Title: Permit 25-454: 7380 Minnewashta Parkway – Single-Family Home Construction

Prepared by: Jenna Christenson, Permitting Assistant
952-641-4504
JChristenson@MinnehahaCreek.org

Recommendation:

Approval of Minnehaha Creek Watershed District (MCWD) permit application, with permit issuance conditioned on the following:

FIGURE 2
Wetland Buffer Requirements

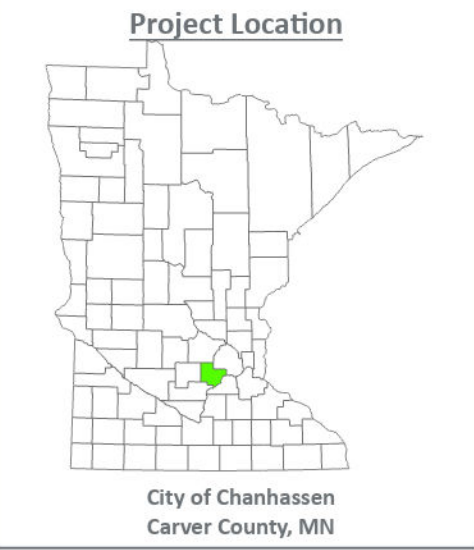
Section 5(c) states that buffer width at any point may be reduced to no less than 50% of the 24-foot Base Width, provided total buffer area is maintained. The proposed project conditions result in an area of 1,428 square feet not meeting the 12-foot minimum width, as depicted in Appendix A of Attachment A.

Due to proposed retaining wall and new bituminous driveway, the project has a buffer **deficiency of 1,428 square feet**, areas not meeting the 12-feet minimum average width requirement, as depicted on attached Figure 2.

As referenced in the "Exception Request" section below, the Applicant has requested an exception to section 5 of the Wetland Protection Rule, which requires the 24-foot buffer, and specifically to section 5(c) which requires that the buffer width at any specific location be no less than 50% of the base width minimum of 24-feet. Under these conditions, a buffer area of 5,567 square feet is required. The applicant instead proposes a buffer that ranges from 0 to 24 feet, and has a total square footage of 10,617 square feet.

FIGURE 3
Proposed Buffer

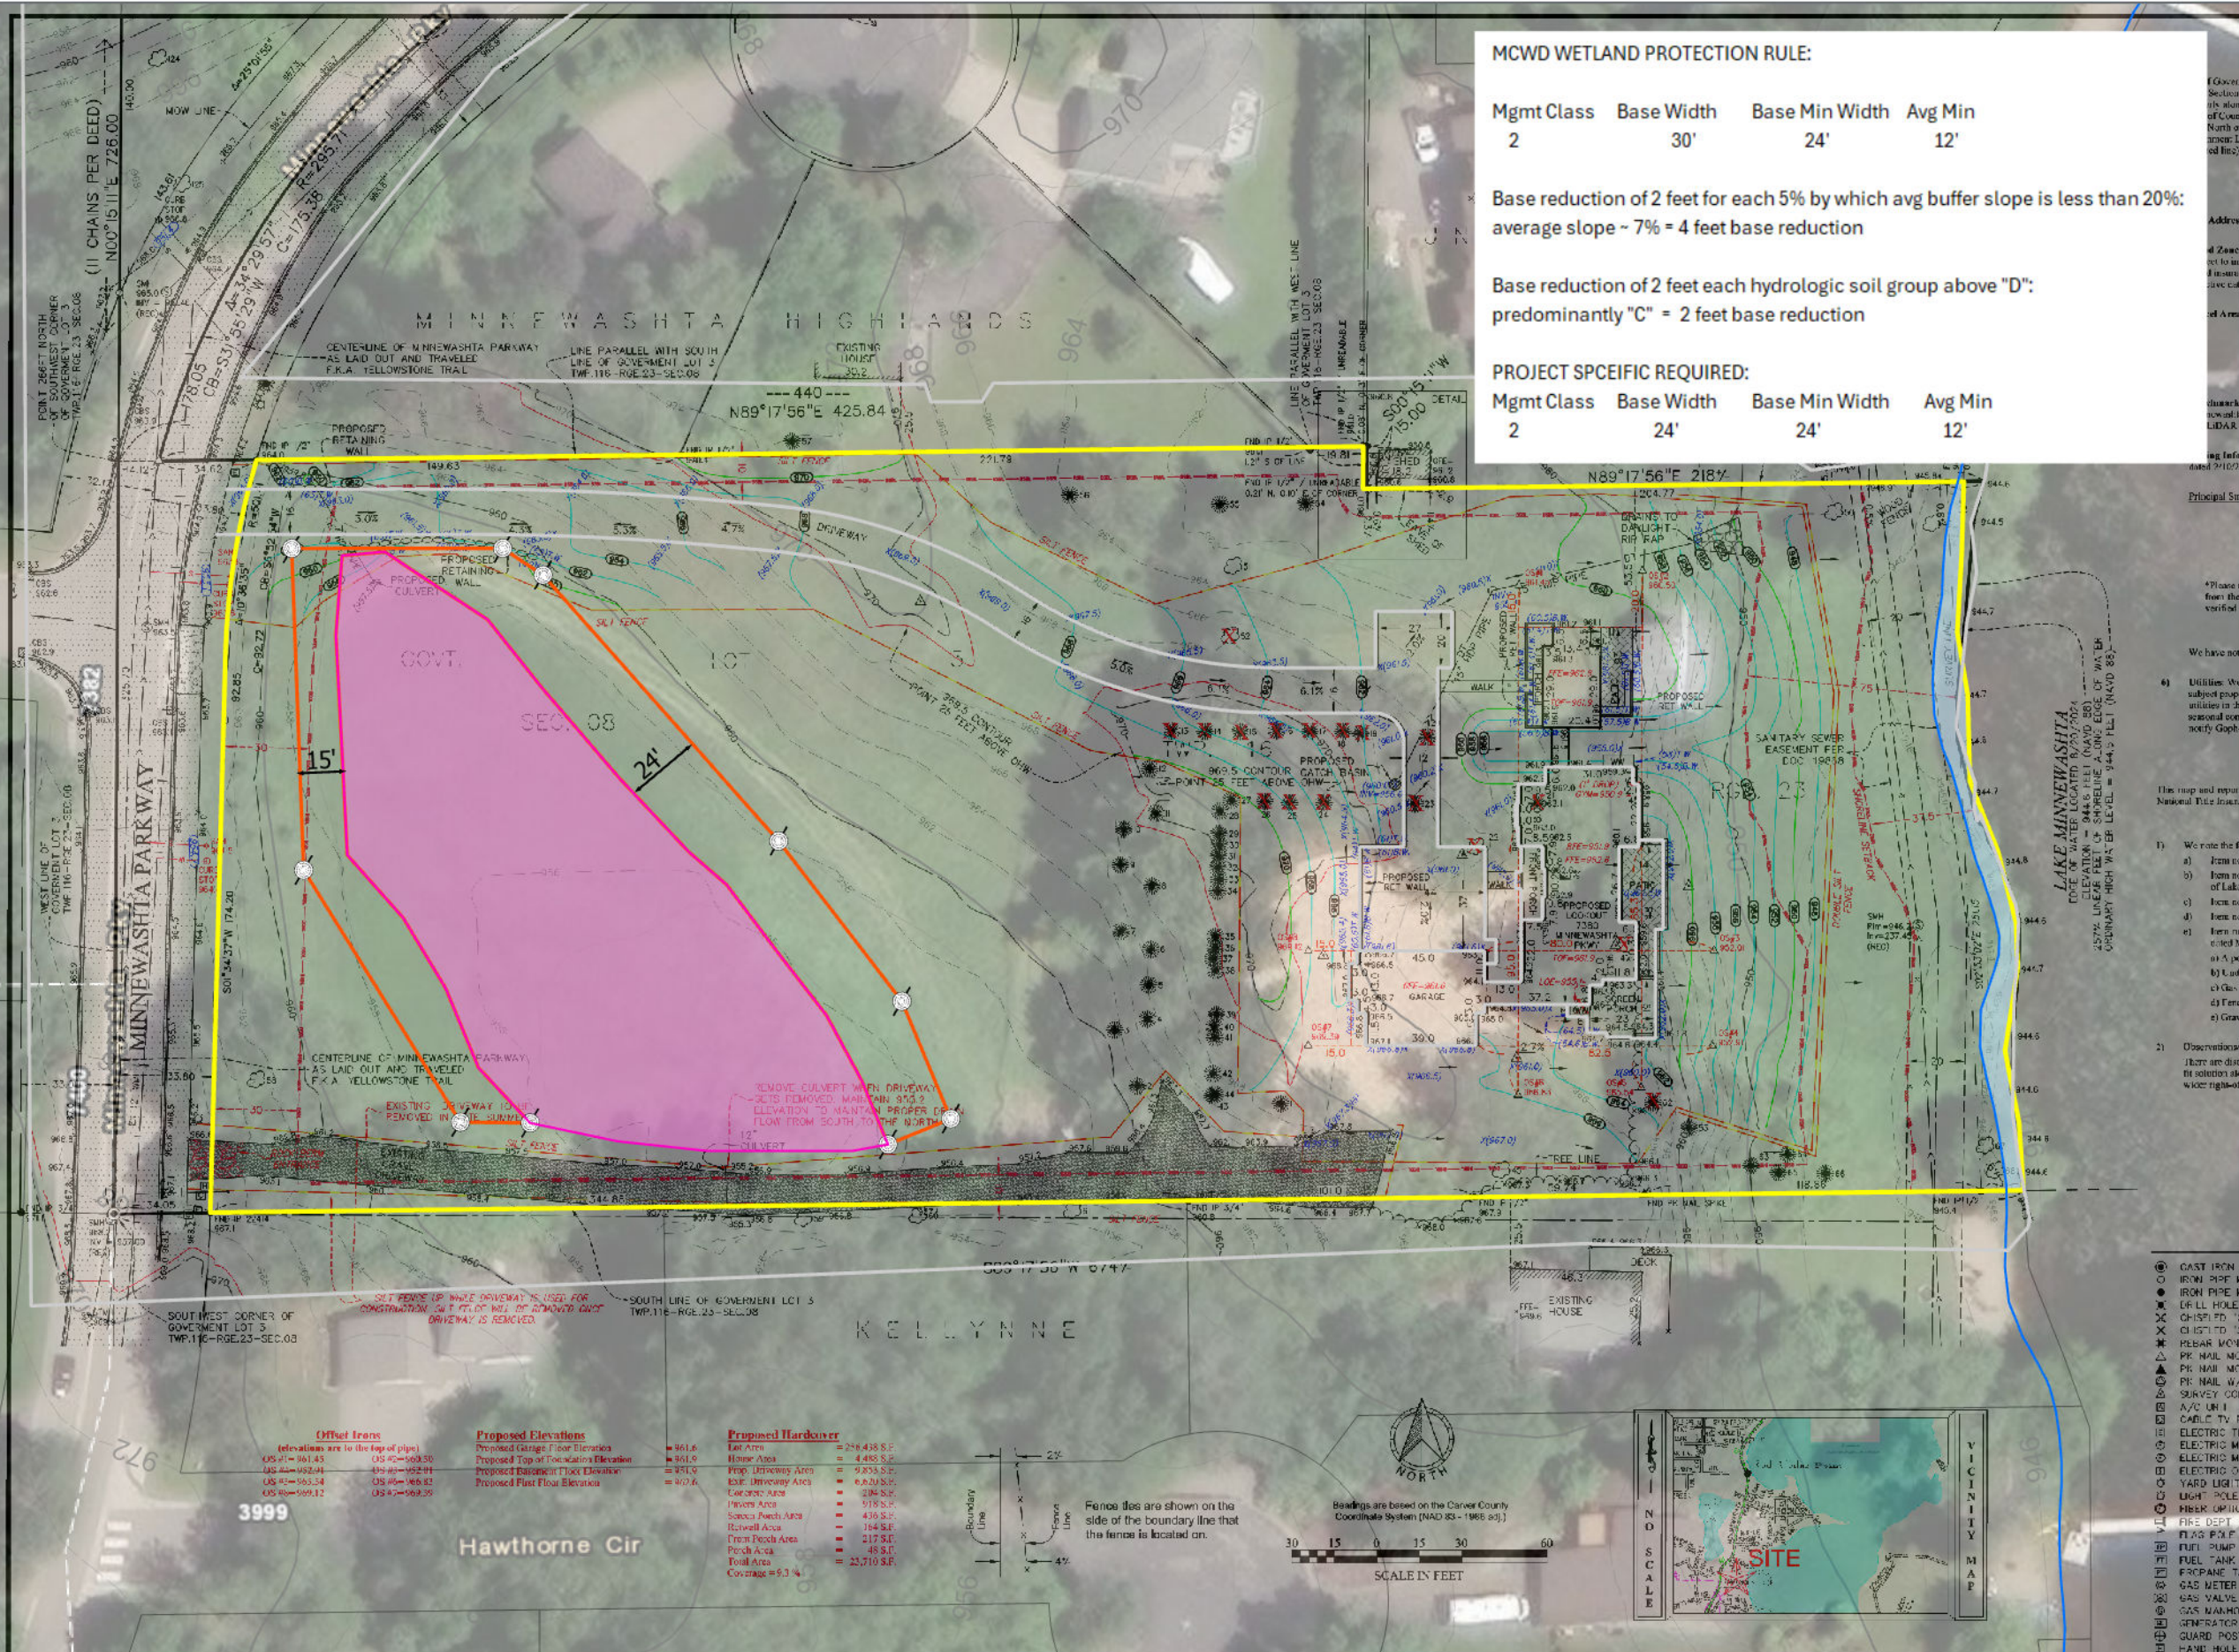
The project proposes a 24-feet wide buffer along the east and approximately 15-feet wide buffer along the west side of Wetland #1 totaling **10,617 square feet** as depicted on Figure 3 to be seeded with MnDOT Mesic Prairie Native Seed Mix 35-341 and augmented with individual plug seedlings.

The proposed buffer provides the required 24-feet wide buffer, not only where possible downslope of new constructed impervious, but also along the entirety of the east side of Wetland #1. Additionally, the project proposes 15-feet buffer along the entirety of the west side of Wetland #1. The total proposed buffer of 10,617
